## MCQV3 / MCQI3-Ø63

### Repair kits change Notification

Change descriptions:

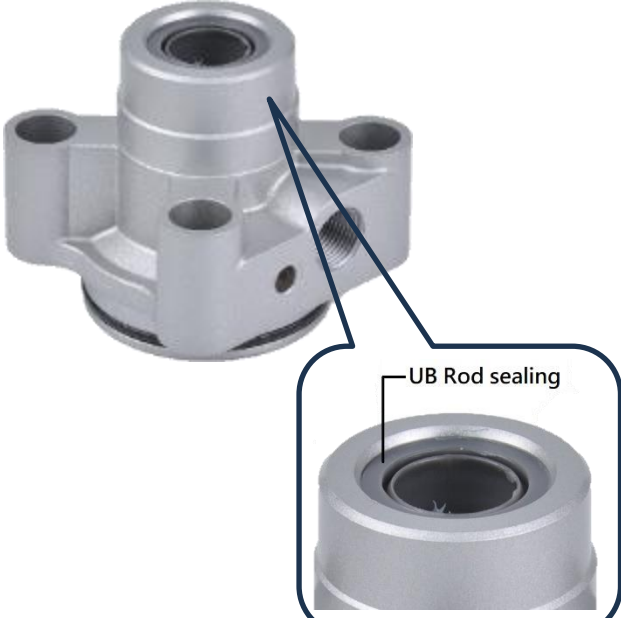
Before	After
 <p>1. Rod sealing</p>	 <p>1. Rod sealing 2. Cushion pads *2pcs (for piston) <b>Newly Added.</b></p>
<p>Profile difference</p>  <p>Washer+ORA</p>	<p>Profile difference</p>  <p>UB Rod sealing</p>
